**Entrance Corridor Review Board
Certificate of Appropriateness Request for Redevelopment of 1185 Seminole Trail**

**Planning Commission Regular Meeting
Date of Planning Commission Meeting: July 8, 2025**

Project Name: Residential Seminole Trail
Property Street Address: 1175-1185 Seminole Trail (formally 1185)
Property Owner: Brownwood Properties, LLC, et al
Project Planner: Dannan O'Connell
Zoning: Highway Corridor with Entrance Corridor Overlay (prior zoning applies.)
Entrance Corridor Overlay District: Corridor 1, Route 29 North (from corporate limits to Ivy Road),
Sub-Area A (corporate limits to 250 Bypass)
FLUM designation: Urban Mixed-Use Node
Tax Map/Parcel #: 41C001000
Site Acreage: 4.04 acres.
ERB staff report prepared by: Jeff Werner, AICP, Preservation and Design Planner
Submittal: [Attached] Hord-Coplan-Mach drawings *Residential Seminole Trail ERB Exhibit*, dated May 2025, 24 sheets. (Application submitted by Collins Engineering.)

ELEVATIONS & MATERIALS

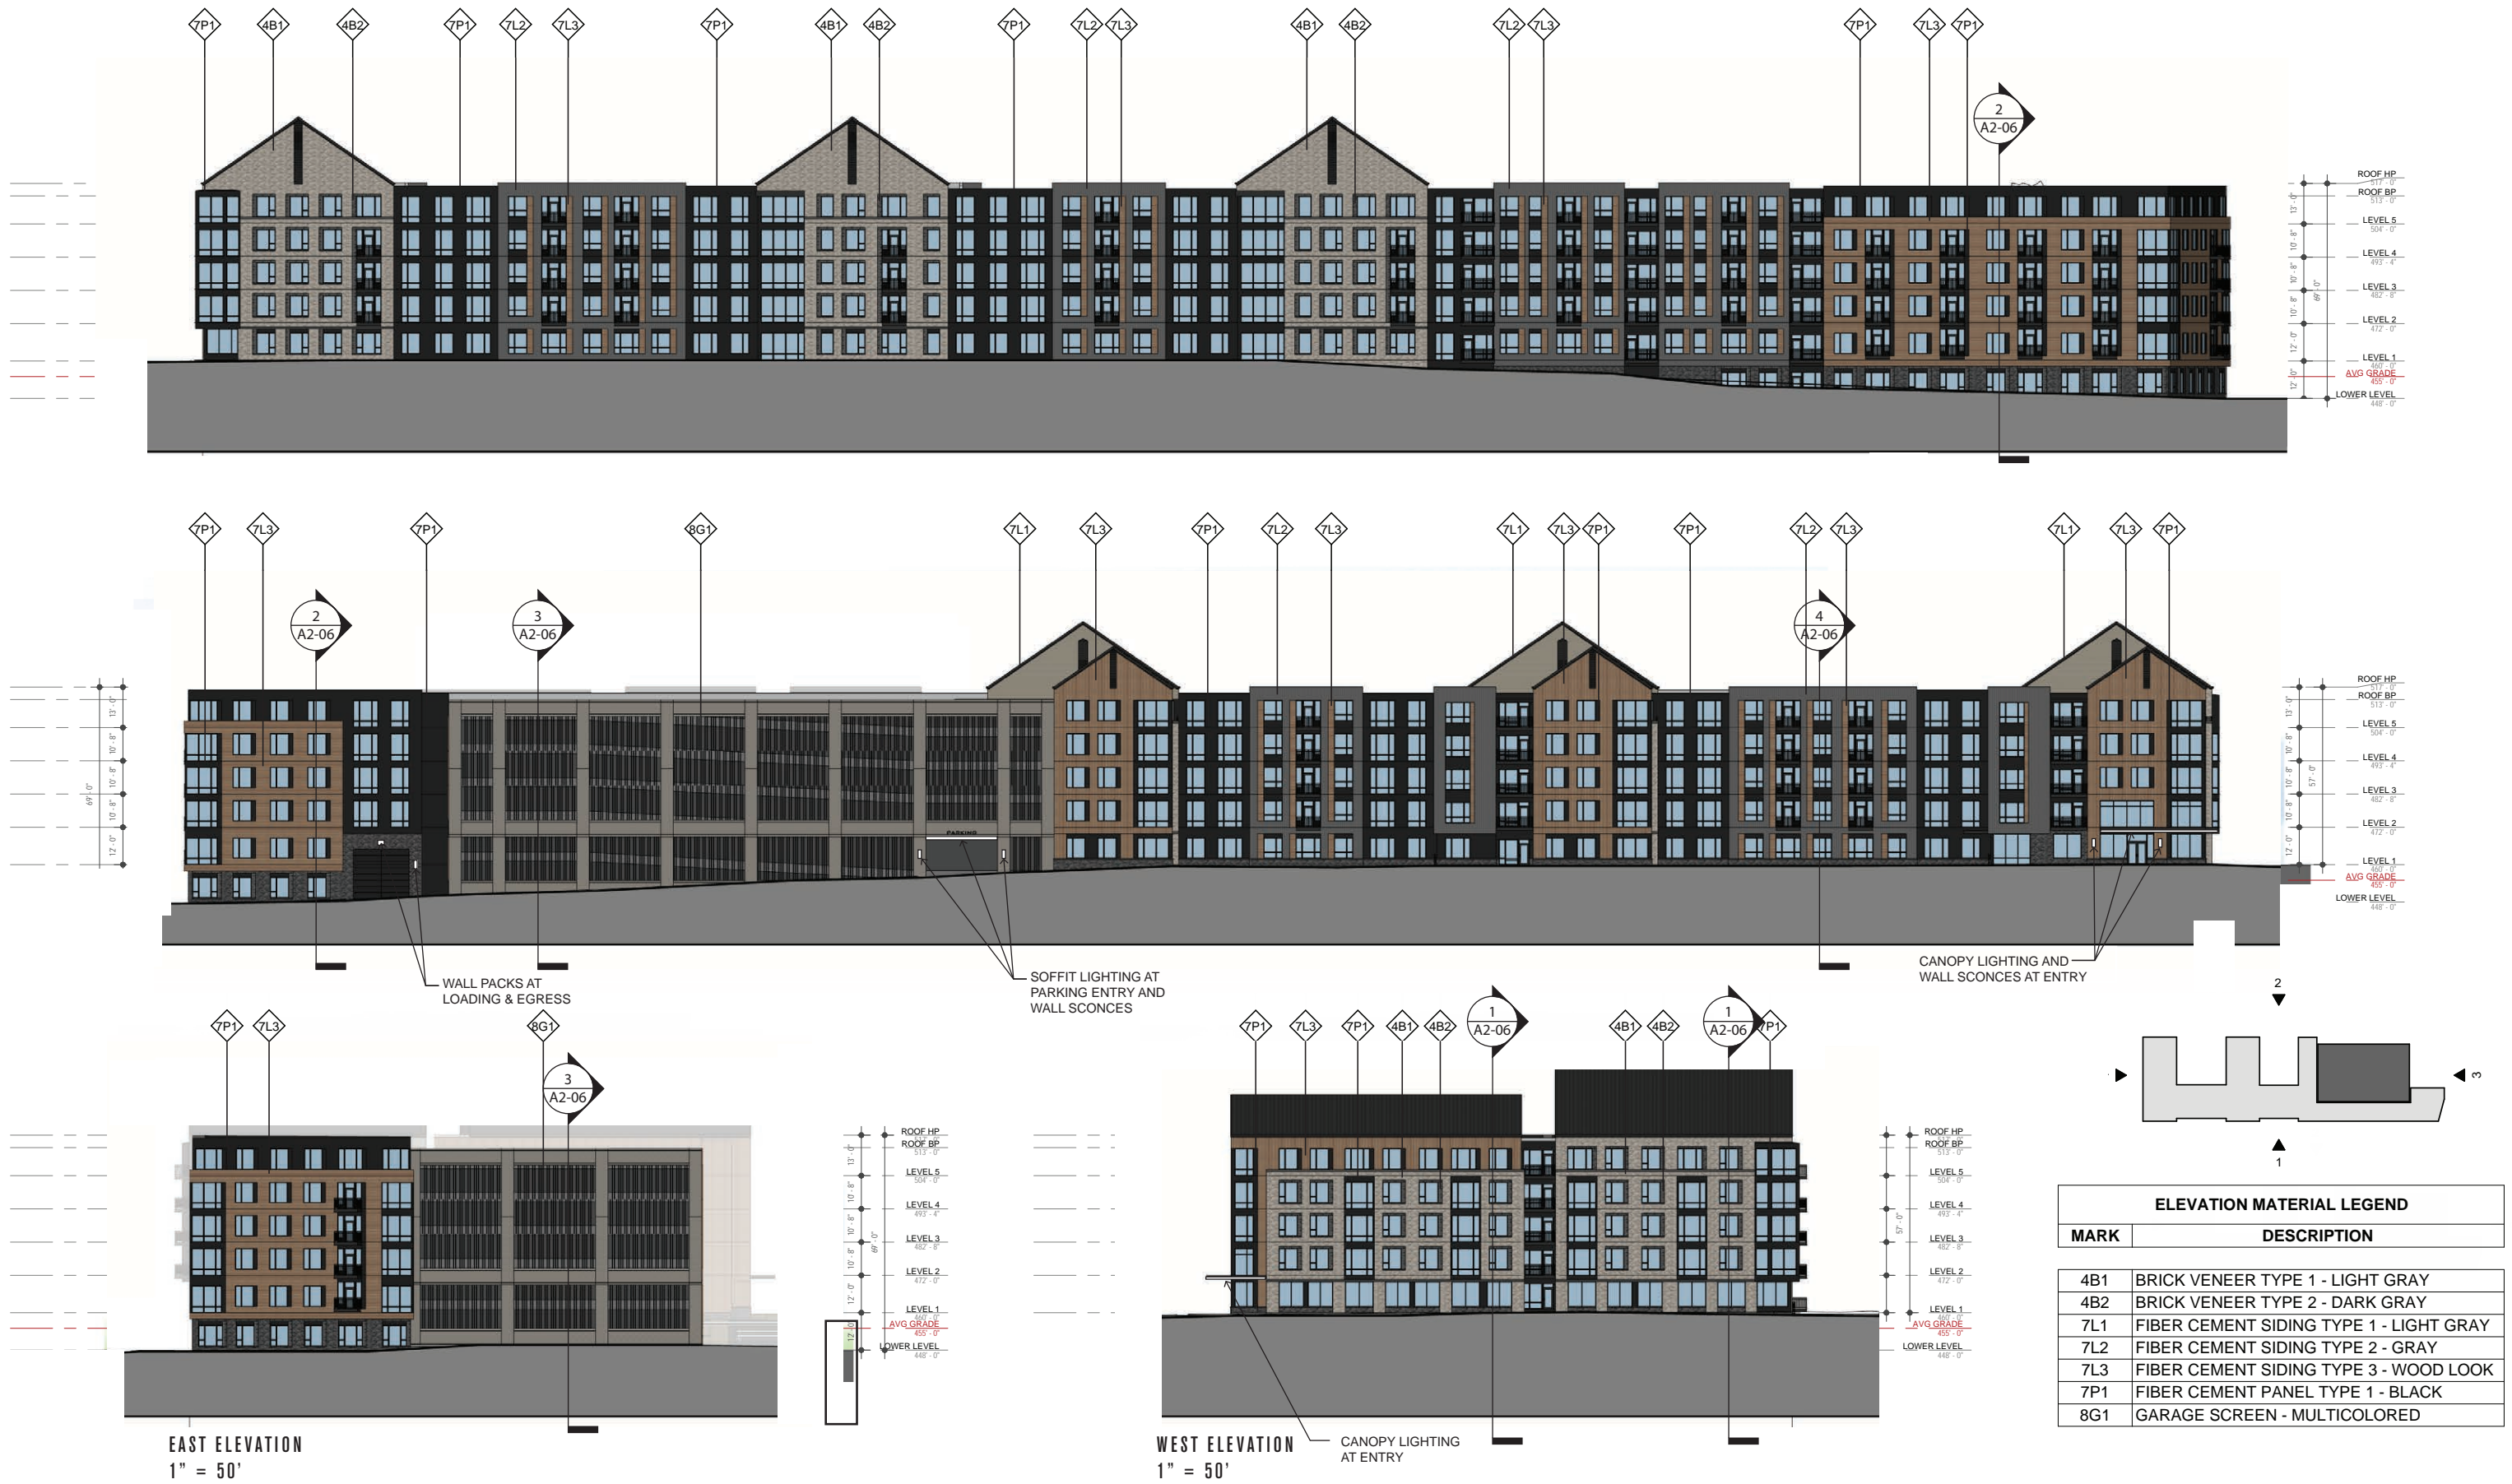
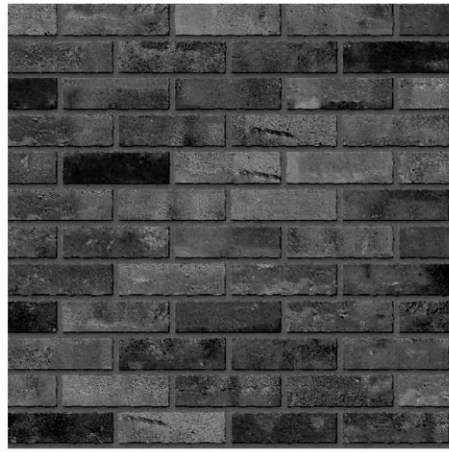
Brick and stucco are commonly used throughout Charlottesville. Most nearby brick buildings have red brick; however, the tan and brown are not incompatible with the EC. Siding is a traditional material more typically seen on older houses, though it has been frequently applied on commercial buildings. The vertical alignment is a contemporary interpretation of this traditional material and architectural element. The proposed color palette is compatible with this EC.

Chapter IV: Guidelines for Buildings, G. Color	Applicant's Comment	Staff Comment
1. A coordinated palette of colors should be created for each development. This palette should be compatible with adjacent developments.	Acknowledged. See proposed palette in submission.	Color palette is compatible with this EC. Most nearby brick buildings have red brick; however, the tan and brown are not incompatible with the EC.

5. Use color variation to break up the mass of a building and provide visual interest.	Acknowledged. Along with color changes, wood-look cement board has been used to create visual interest.
